## **Reviewer 1**

Review of “Development of a Forced Advection Sampling Technique (FAST) for Quantification of Methane Emissions from Orphaned Wells”

## Reviewer 2

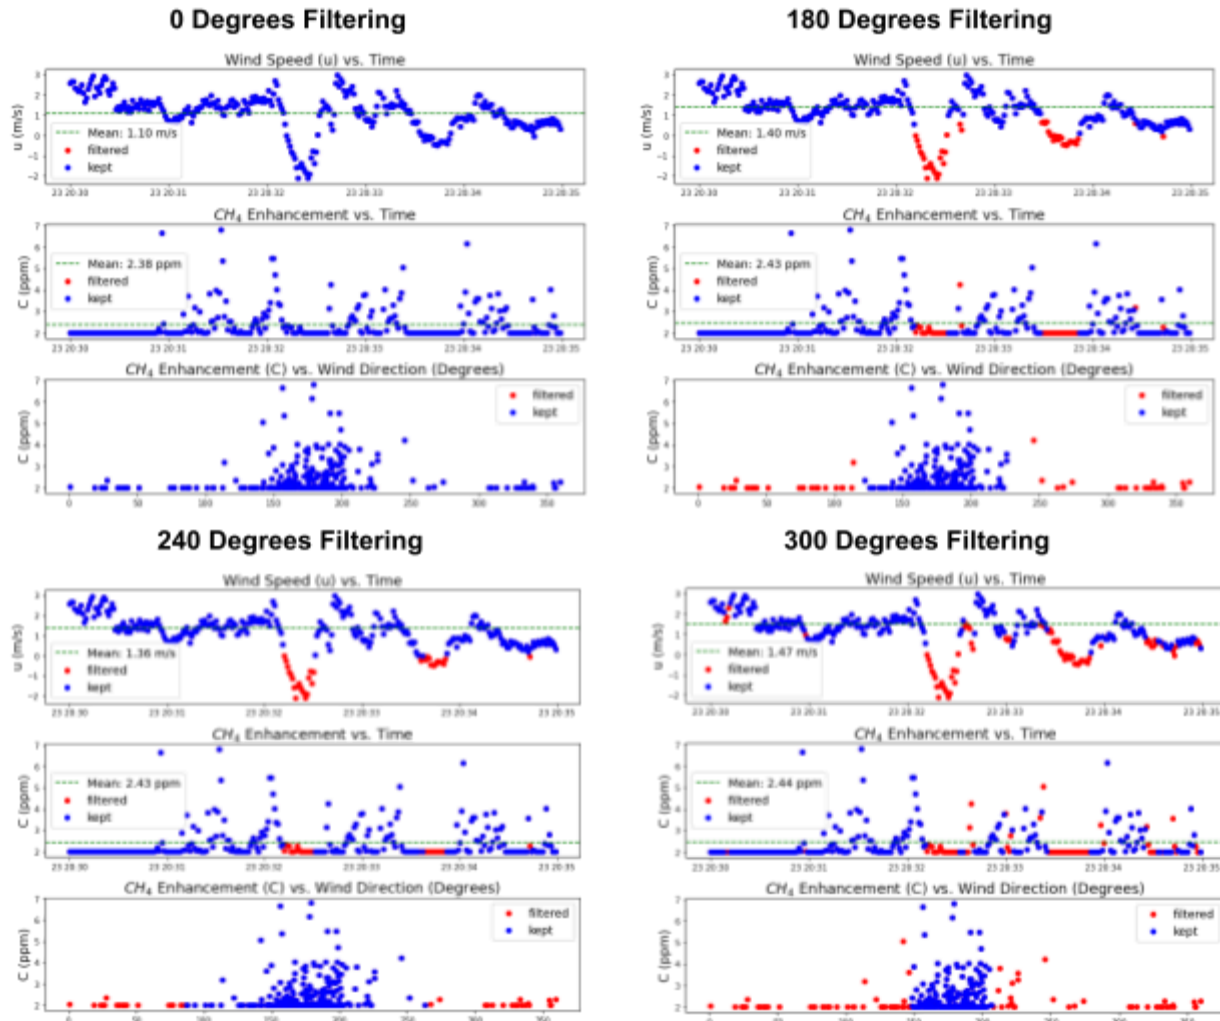
Some discussion of the filter angle needs to be included in the methods section of the text. It is hinted at in Figure 5, but never really discussed. In Figure 4, the caption says data were filtered to remove points coming from the negative x direction (180 degrees). How many points were these relative to the total? Later, a filter of 300 degrees is used, but I don't know what that means. If 180 degrees is the negative x direction, I am guessing a crosswind be either 90 or 270 degrees? In line 352, the authors state the crosswind is filtered as the filter angle approaches 360. Is that the same as saying it approaches 0? Or in line 356, when the authors state a filter angle of 300 filters out all crosswind interference, does this mean they are only looking at 60 to -60 degree wind directions? Or from 120 to -120? Since so much of the discussion (Fig. 16, Table 4, etc.) depends on understanding this filtering, I don't think I can give a full final review of this manuscript.

Thank you for your very insightful comments and review. The lack of discussion of our filtering methods was a pretty glaring hole in the methodology and we have included an entire new section of the paper to address this, see below.

Figure 5 illustrates the impact of varying the filter angle on the time series of wind and methane concentration data, for a 1 g/hr release from the Richmond Field Station experiment (N = 300). As the filter angle decreases, more data from crosswind and background noise is excluded (shown in red) and the mean wind speed (u) and concentration (C) values change, resulting in different estimates from the FAST method. We found that a filter angle of 300° effectively aligns the analysis with wind directions closely aligned with the source when accounting for plume spread within  $x < 2$  m.

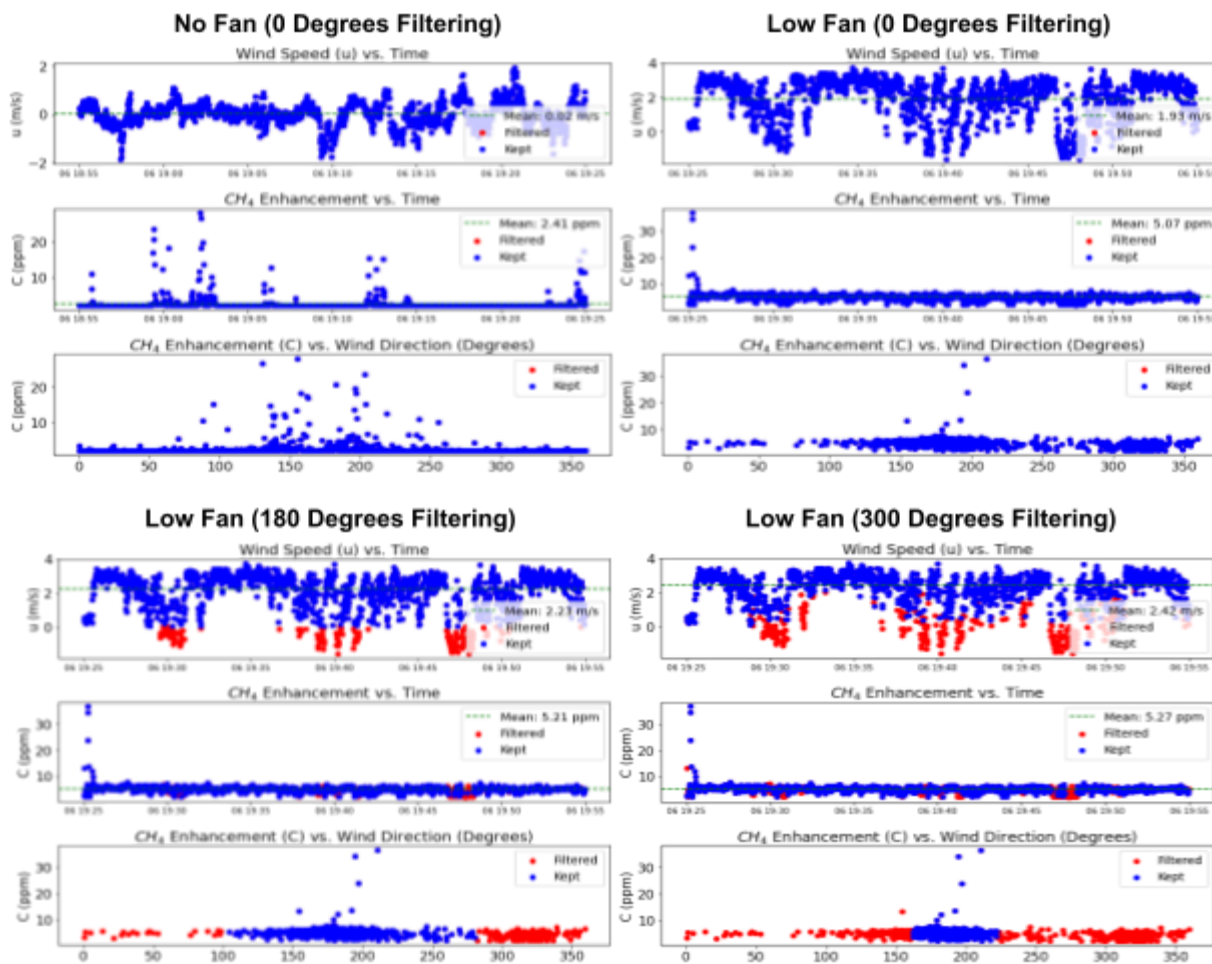
It seems like one of the bigger uncertainties is what Figure 6 would look like for concentration in the y-z plane, especially for cases like Hooper #41. In fact, concentration or mixing ratio data are missing throughout the manuscript. Could the authors show concentration data for the reader to get an idea of how much variability and plume enhancement are involved in these calculations?

This is a very good point. Unfortunately, we did not have the time or equipment to measure these vertical profiles, but would like to do this in future studies to verify this plume behavior. In addition to the above figure we are also including a similar figure showing the concentration data for a single well (Rayburn #7) with and without the fan on to address this. See below:

Figure XX illustrates the effect of using the fan on the time series of concentration and wind speed measurements at Rayburn #7, providing insight into the variability of methane concentrations and plume enhancements. Without the fan (upper left), the average wind speed in the x-direction (u) over the 30-minute measuring period was approximately 0 m/s. However, infrequent gusts in the x-direction caused spikes in methane concentrations, ranging from about 10 to 20 ppm above background levels. These spikes were spread across a wide range of directions, between 100 and 250°, indicating variable plume dispersion under stagnant conditions. With the fan on at a low setting, the mean wind speed in the x-direction (u) increased to approximately 2 m/s, and the plume became more stable. The methane concentration spikes were more concentrated in direction, between 180 and 210°, corresponding to the airflow from the fan. While a large spike was observed at the start of the low fan measurement, likely due to the fan turning on, the concentration stabilized to around 5 ppm above background levels.

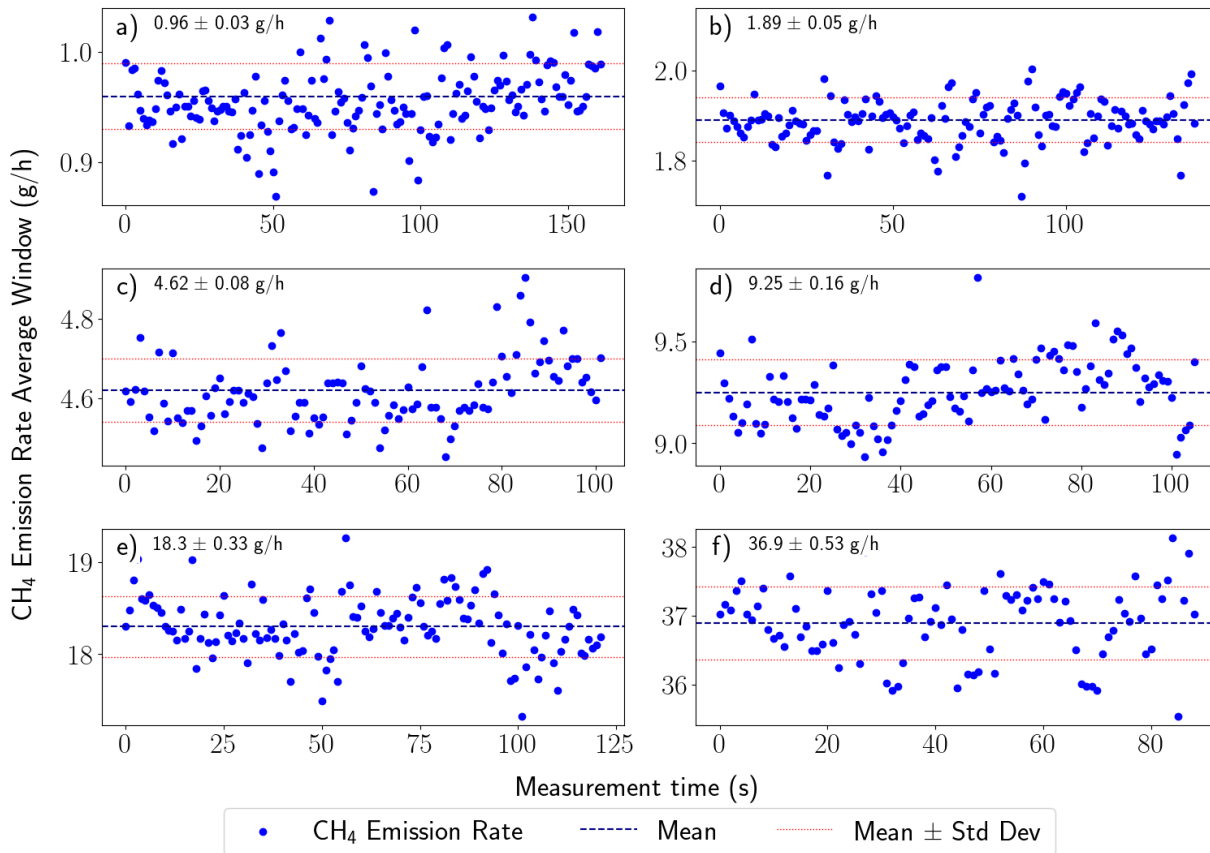
Figure 7, perhaps add the standard deviation of the emission rate to show “accuracy and precision ... decrease” as stated in the caption.

The figure has been updated to include mean and standard deviation. This figure has also been moved to a new section in the appendix (Appendix B: SEMTECH Measurements) as they are not entirely relevant to the FAST method directly (per another reviewer's suggestion).
